Subject: Limerick Generating Station, Units 1 and 2  
Technical Specifications Change Request

LIMERICK GENERATING STATION, UNITS 1 AND 2

No. 87-05-0

"Expanded Test Tolerance for 480 Volt Molded Case  
Circuit Breakers"

FIGURE 1  
 CHARACTERISTIC TRIPPING CURVES FOR  
 SELECTED #8 PENETRATION CONDUCTOR'S  
 THERMAL PROTECTIVE DEVICES

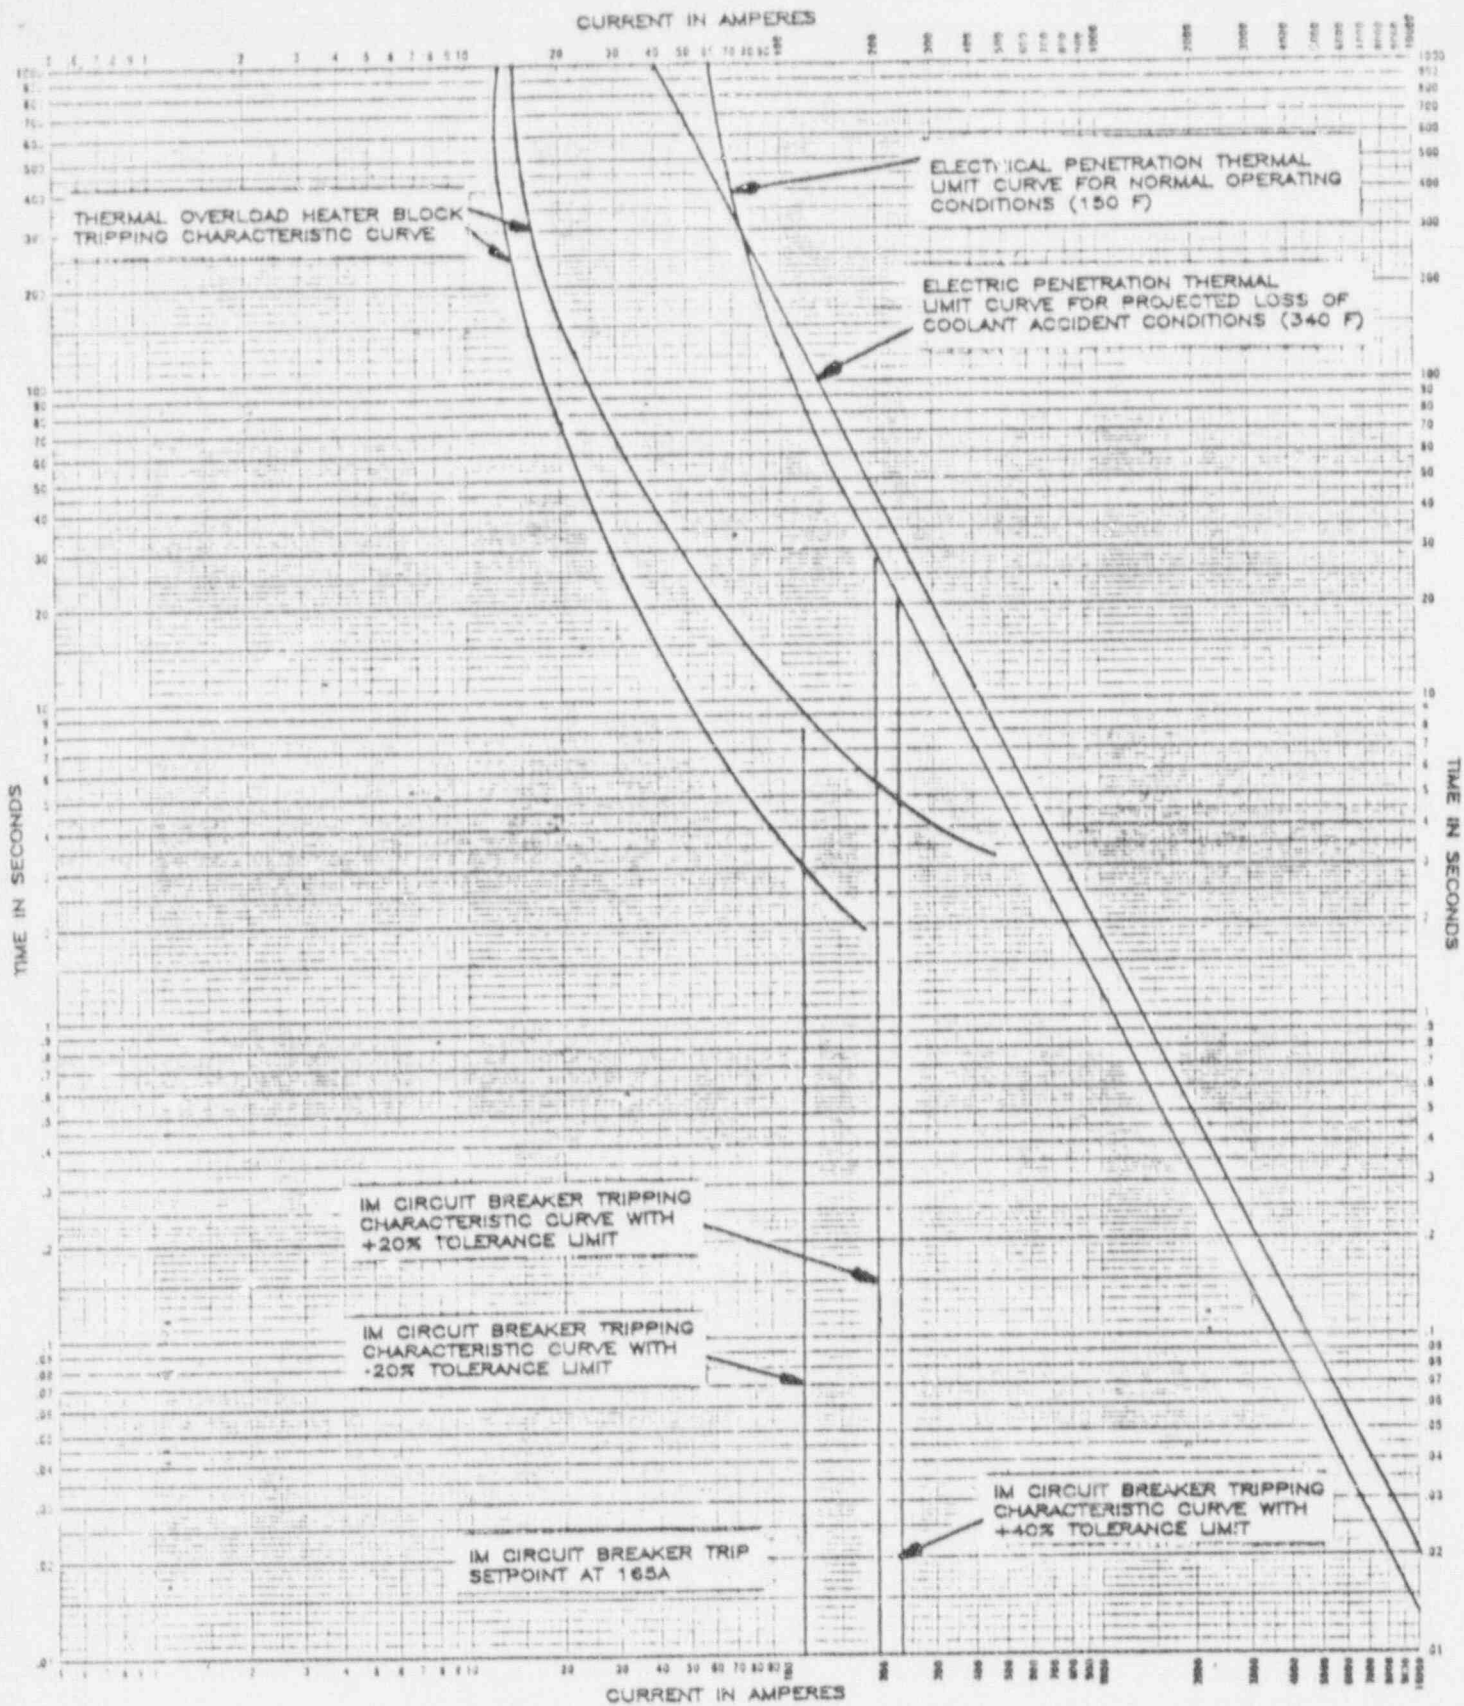
The expanded tolerance of -20%/+40% will be used in the same fashion as the current TS testing tolerances (i.e.,  $\pm 20\%$ ) for determining the circuit breaker operability. The maximum permissible IM trip setting (i.e., the breaker setpoint plus the maximum tolerance allowed by the TS) was plotted on a time-current curve for each penetration conductor to verify the degree of protection for each penetration conductor and coordination with all upstream protective devices assuming a maximum tolerance +40% penetration assembly. Figure 1 (attached) is an example of a time-current curve for a penetration conductor that was evaluated with an IM circuit breaker in the circuit with a setpoint of 165 amperes. This figure shows that the circuit breaker should trip between 132 and 198 amperes with a testing tolerance of  $\pm 20\%$ , and should trip between 132 and 231 amperes with a testing tolerance of -20%/+40%. In all cases, the time-current curves for the IM circuit breakers indicate that the breakers will trip before the thermal limit of the associated penetration conductor is reached. In addition, calculations were performed using the expanded tolerance of -20%/+40% for each effected penetration assembly to determine if there was any reduction in the protection afforded by the circuit breakers. These calculations concluded that there is not a significant reduction in the level of protection, and that these circuit breakers will trip before the thermal limit of the associated penetration conductor is reached; thereby, providing the required thermal protection for the Primary Containment electrical penetration assemblies.

The proposed maximum IM trip setting (i.e., the breaker setpoint plus the maximum tolerance allowed by the proposed TS change, assumed  $+40\%$ ) was plotted on a time-current curve for each Primary Containment electrical penetration conductor to verify protection for each conductor and coordination with all upstream protective devices. In all cases, the circuit breakers were verified to trip before the thermal limit of the associated penetration conductor is reached. Therefore, the safety-related function of the 480 volt IM molded case circuit breakers is not affected by the expanded testing tolerance since these breakers will continue to provide the required overcurrent and thermal protection for penetration conductors and Primary Containment electrical penetration seals. The LGS Updated Final Safety Analysis Report (UFSAR), Sections 8.1.6.1.12 and 8.1.6.1.14, were reviewed in making this determination. Therefore, since the circuit breakers will continue to perform as analyzed in the UFSAR, neither the probability nor the consequences of an accident previously evaluated will be increased.

Calculations were performed for each penetration conductor and concluded that for overcurrents at the maximum IM trip setting (i.e., the breaker setpoint plus the maximum tolerance allowed by the proposed TS,  $+40\%$ ), the circuit breakers will trip before the thermal limit of the associated penetration conductor is reached; thereby, providing the required thermal protection for the Primary Containment electrical penetration seals. These calculations did reflect a small reduction in the protection afforded by the circuit breakers; however, since the use of the proposed expanded range is used for field verification testing purposes only and does not involve a change to the breaker trip setpoint, the 480 volt IM molded case circuit breakers in conjunction with other protective devices (e.g., back-up thermal-magnetic circuit breaker, thermal overload heater block) will continue to prevent thermal degradation of Primary Containment electrical penetration seals.
